SITE PLAN REVIEW AGENDA

11/9/2022 - 9:00 A.M. (Via Microsoft Teams)

SITE PLAN NO: SPR22173

PROJECT TITLE: Sequoia Plaza Center

NOTE PAZ

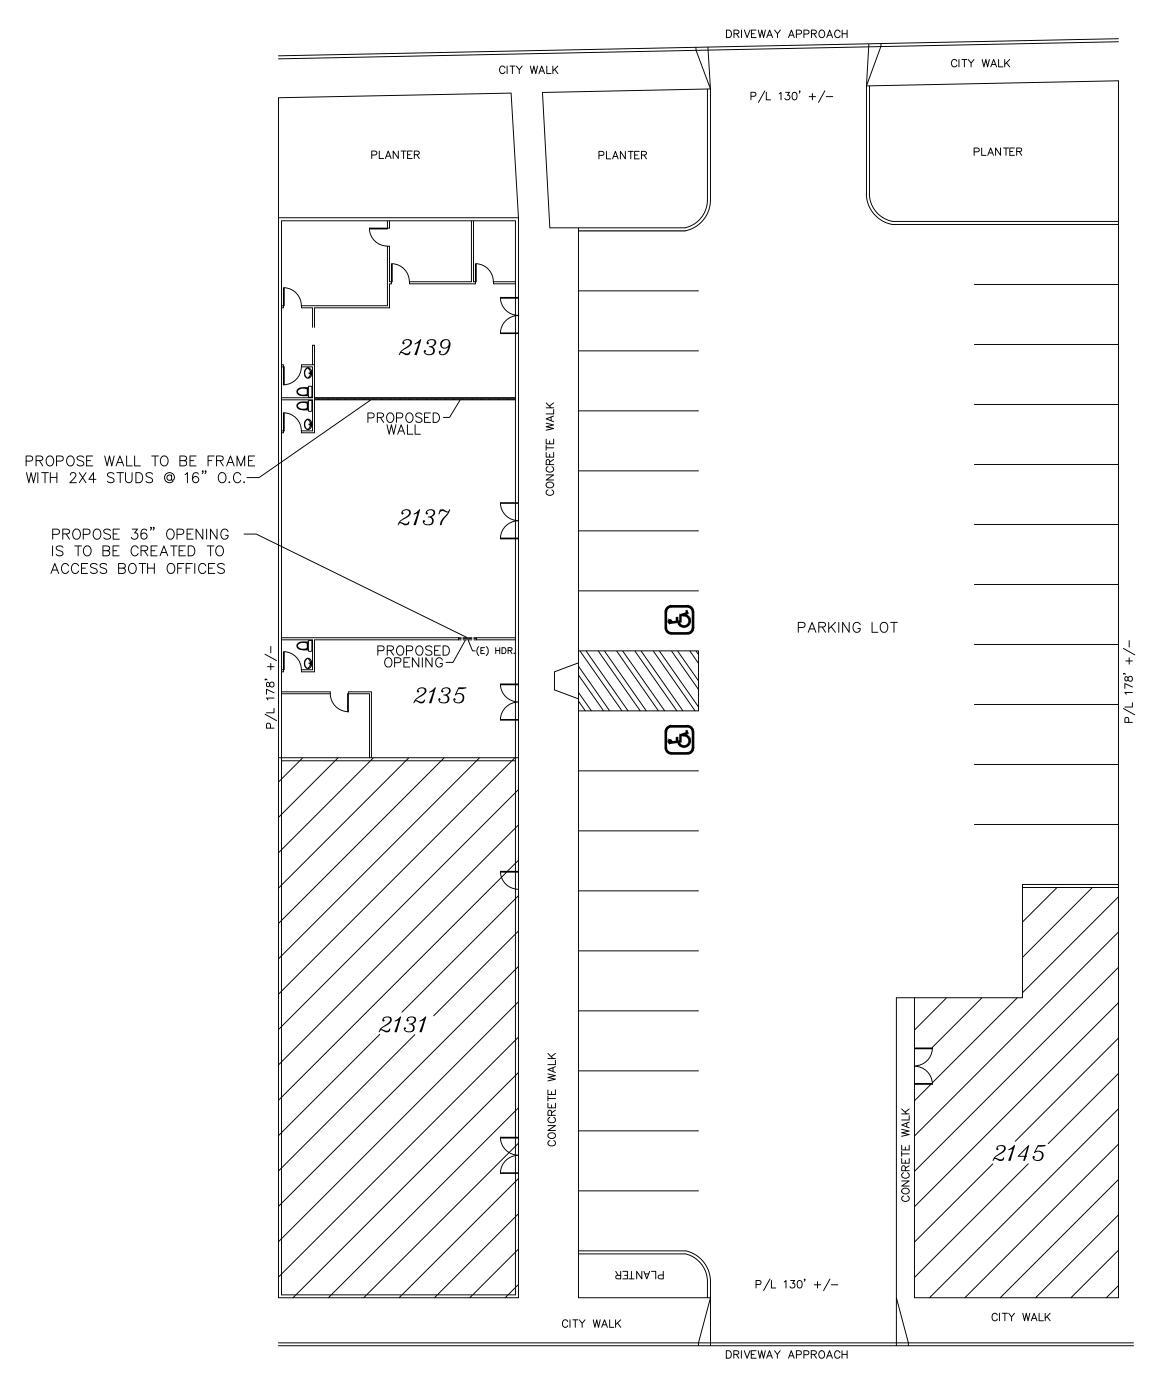
ELECTRICAL RECEPTACLE DUTLETS SHALL SE INSTALLED WITH THE BOTTOM OF DUTLET BOX AT 15 INCHES MINIMUM FROM THE FRINSH PLOCE. 118-306.1.2 NOTE ON PLANS. Subject: Text Box Page Index: 2 Author: Val Garcia

NOTE ON PLANS.

PROPOSED WALL
JOSE TREVINO
2137 W WHITENDALE AVE
VISALIA CA, 93277

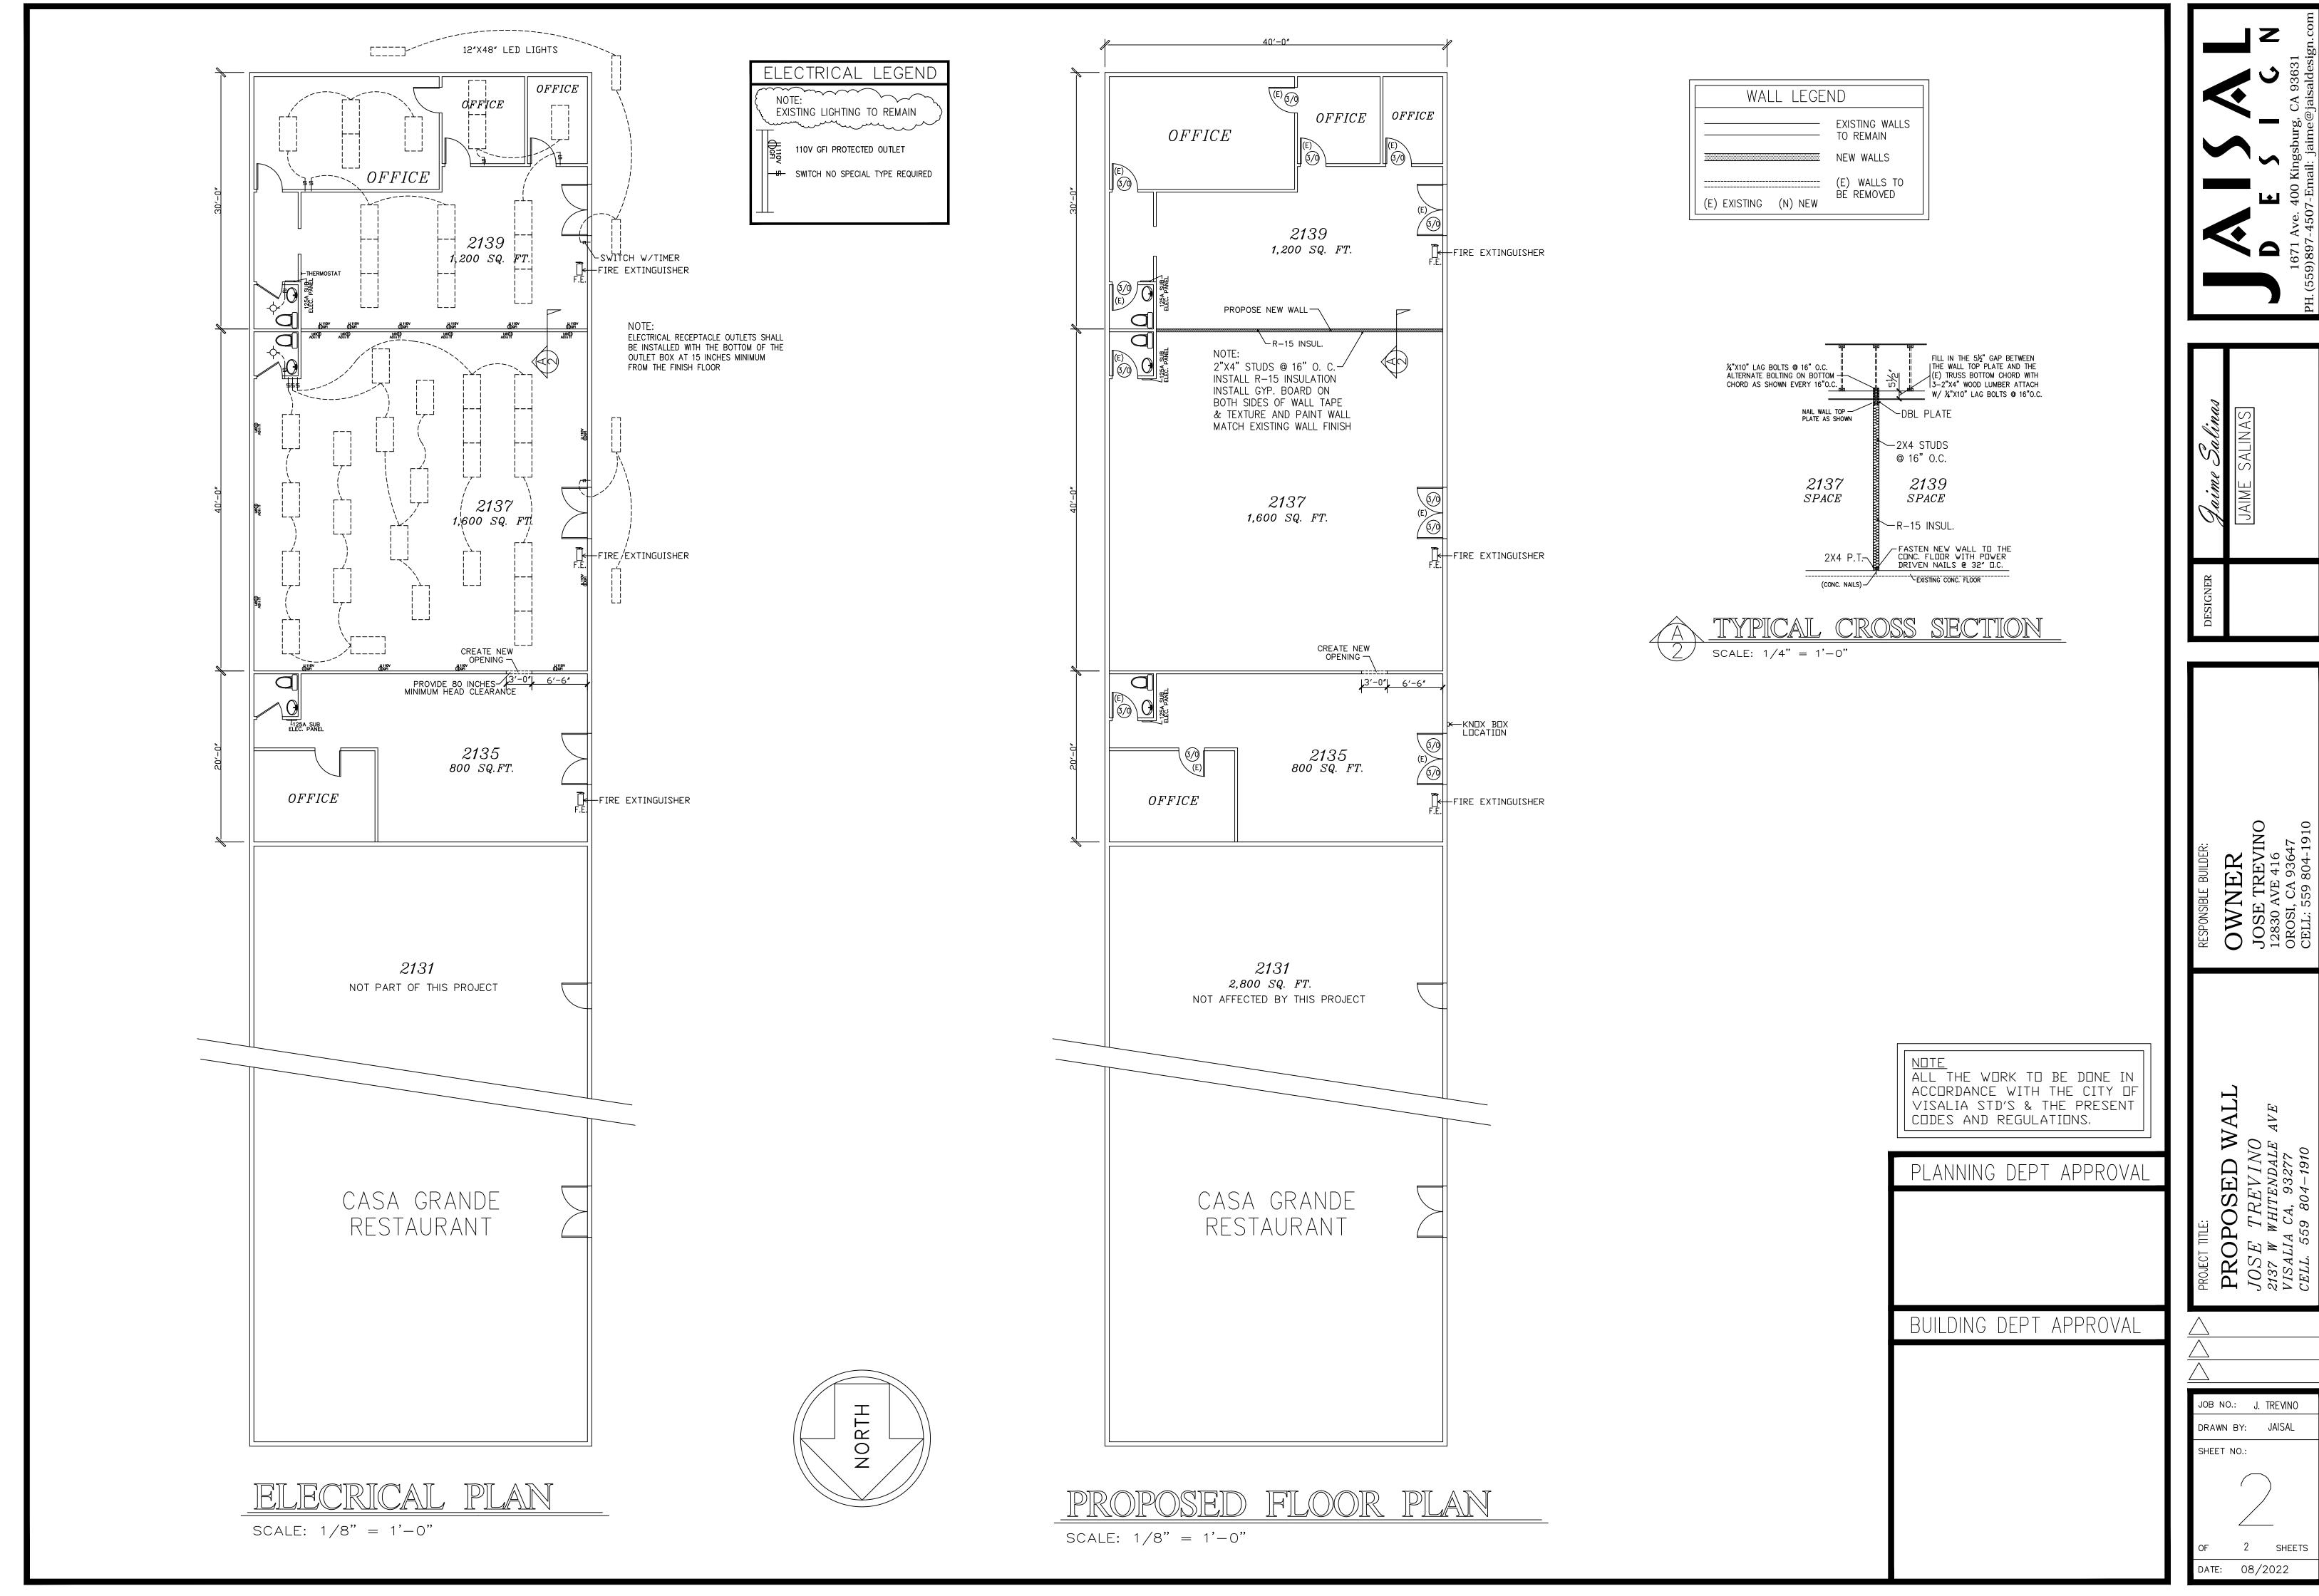
SHOW GENERAL LIGHTING LAYOUT FOR EACH NEW SPACE CREATED BY NEW WALL SEPARATING TENANT SPACE 2139 AND 2137. GRAPHICALLY SHOW ON PLANS WITH INDEPENDENT SWITCHING CONTROLS FOR EACH TENANT.

PROVIDE 80 INCH MINIMUM HEAD CLEARANCE

SHOW LOCATION OF THE REQUIRED FIRE EXTINGUISHERS ON THE PLANS. THE EXTINGUISHERS SHALL COMPLY WITH THE FOLLOWING:

GRAPHICALLY SHOW ON PLANS.

SHOW THE LOCATION OF THE EXISTING KNOX BOX. IF THE BUILDING DOES NOT HAVE A KNOX BOX THEN ONE WILL BE REQUIRED. THE BOX SHALL BE LOCATED CLOSE TO THE MAIN ENTRY.

GRAPHICALLY SHOW THE LOCATION OF

THE BOX ON THE FLOOR PLAN.

ADDED ON PH 2

ADDED NOTE P#2 EMID SCREWS AT 16 INCHES
